Planning Commission Staff Report

3. APPLICATION: The Ashford of Grove City | Development Plan

Proposal: A development plan for a 160 unit senior living facility

Site Plan

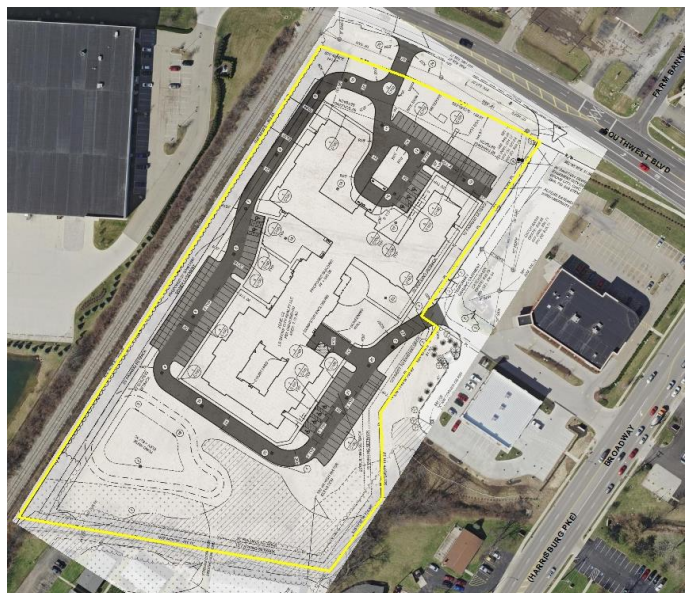
The 7.2-acre site is proposed to have two points of access: a 24' full access curb cut onto Southwest Boulevard and a secondary 24' access drive connecting to the existing private drive on the adjacent CVS property to gain a second access point onto Southwest Boulevard (through the existing right in, right out curb cut) as well as gaining access to the existing full access curb cut onto Broadway from the CVS site. The preliminary development plan was approved with a stipulation that the reconfiguration of access points be considered with the final development plan. To address this stipulation, the applicant

shifted the Southwest Boulevard access point to the west to align with a cut across the street and straightened the entrance drive off this cut. To address concerns related to the access point off the shared CVS drive, the applicant has indicated that a stop sign will be placed on the proposed drive and that they will reach out to CVS about further traffic-calming on CVS's drive. Staff is supportive of further traffic-calming for this drive, such as creating a three-way stop at this new drive. Additionally, the applicant has indicated that the site will not generate much traffic, with most traffic being generated from employees and visitors. It is estimated that there will be approximately 22 vehicles split between both access points during peak morning hours and 34 vehicles during peak afternoon/evening hours.

A 24' drive is proposed to circulate around the site to connect the different ingress/egress areas and the three (3) different parking areas including around the building's main entrance.

Sidewalks are proposed throughout the site connecting to different portions of the building and to the parking areas. The site details sheet (C101) indicates that the sidewalks will be 4' in width; however, recent changes to ADA requirements now require they be at least 5' in width.

A retention pond is proposed in the southern portion of the property. While staff is supportive of the proposed stormwater management on the site, a few additional items are needed around the pond, including a path and additional landscaping, to bring the pond into compliance with the City's pond design standards. Staff recommends the path installed around the pond as well as to meet the required pond landscaping requirements.

3. All sidewalks on site shall be at least five (5) feet in width.
4. Additional landscaping shall be provided around the proposed retention pond that meets Grove City Standard Drawing C-GC-98.
5. A path shall be provided around the proposed retention pond that meets Grove City Standards Drawing C-GC-98,
6. The evergreen hedge along the Southwest Blvd frontage shall be at least 36" in height at installation.
